Central Coast
Local Planning Panel Meeting
Business Paper
03 October 2024

Item No: 3.1
Title: DA/4077/2022 - 12 Beach Parade Canton Beach - Mixed Use Development
Department: Environment and Planning

The subject development application seeks consent for the construction of a five storey shop top housing development comprising four residential units with ground floor food and drink premises and basement parking at No. 12 Beach Parade, Canton Beach. The application has been examined having regard to the matters for consideration detailed under Section 4.15 of the *Environmental Planning and Assessment Act 1979* and other statutory requirements, with issues requiring attention and further consideration addressed in this report.

Figure 9. Proposed Basement Plan.

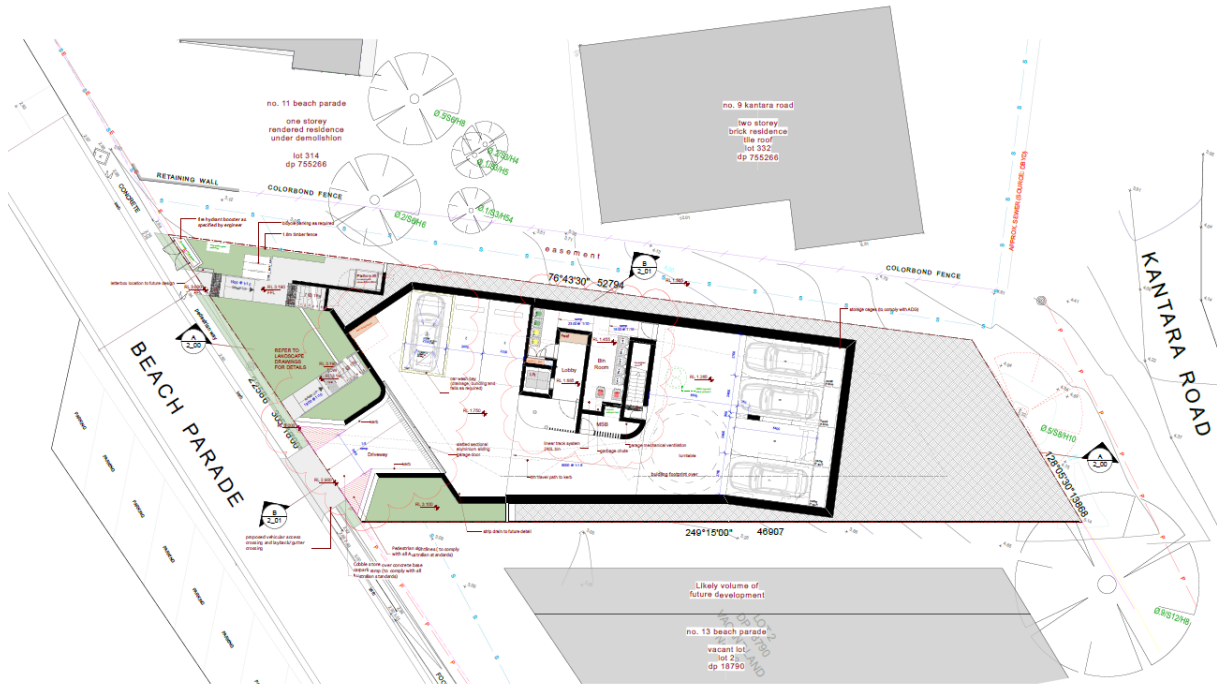
It should be noted that the Landscape Plan submitted with the application has not been updated to reflect the amended architectural plans. The implications of the amended architectural plans for the landscaping scheme are discussed later in this report and form a reason for refusal in this instance **(Reason for Refusal 1d)**.

Figure 10. Proposed Ground Floor Plan.

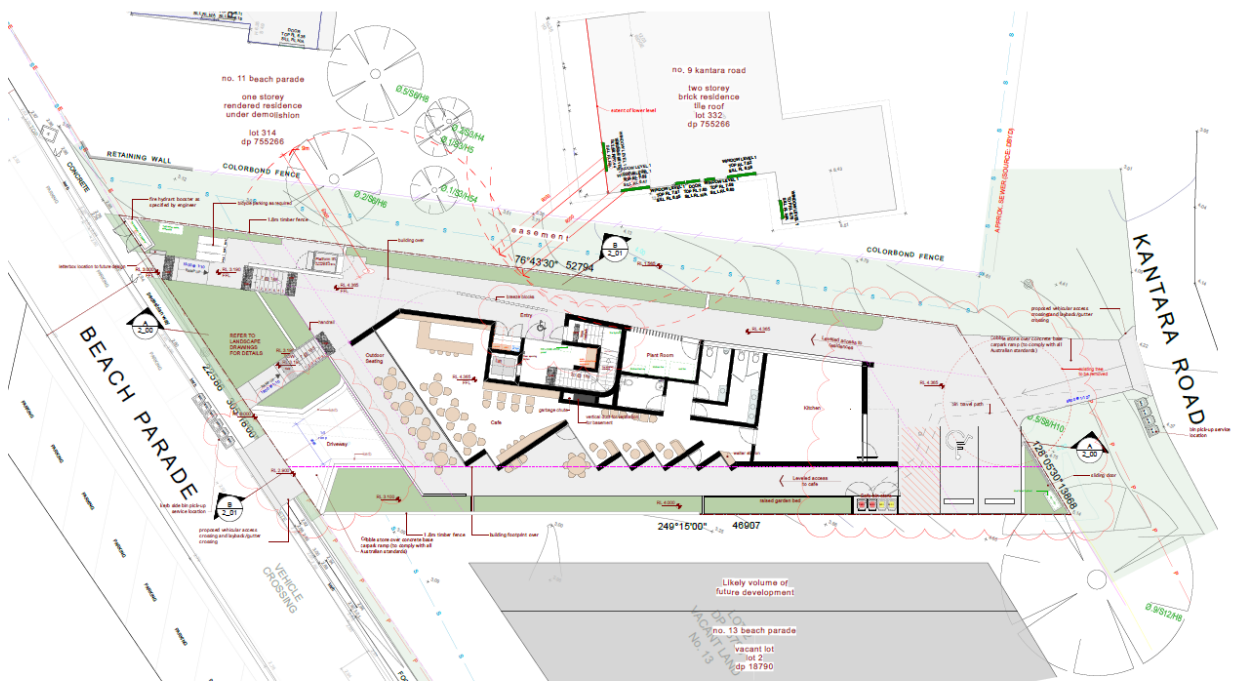
The ground level retail tenancy is shown as a 60-seat café with adjoining forecourt area for outdoor dining fronting Beach Parade as shown in Figure 10 below. The applicant has advised that future fit-out and operational details shall be subject to a separate development application.

Figure 21. Public open space map.

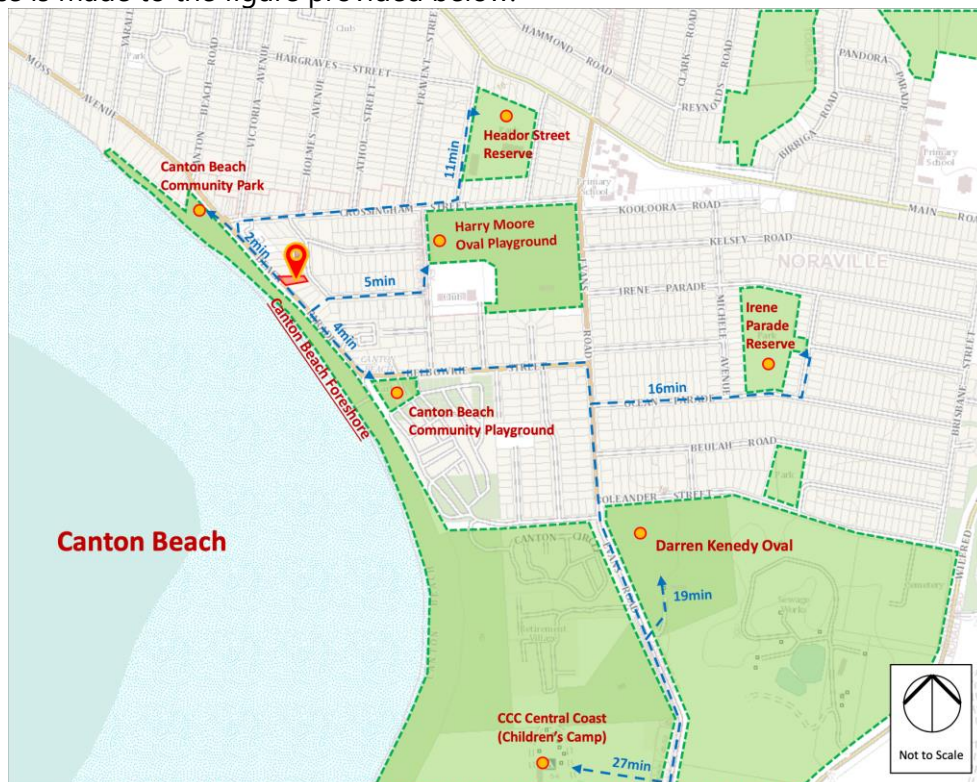
Further, the Applicant submits that based on the above figure that the development has 'enhanced residential amenity and provided opportunities for landscaping, which is consistent
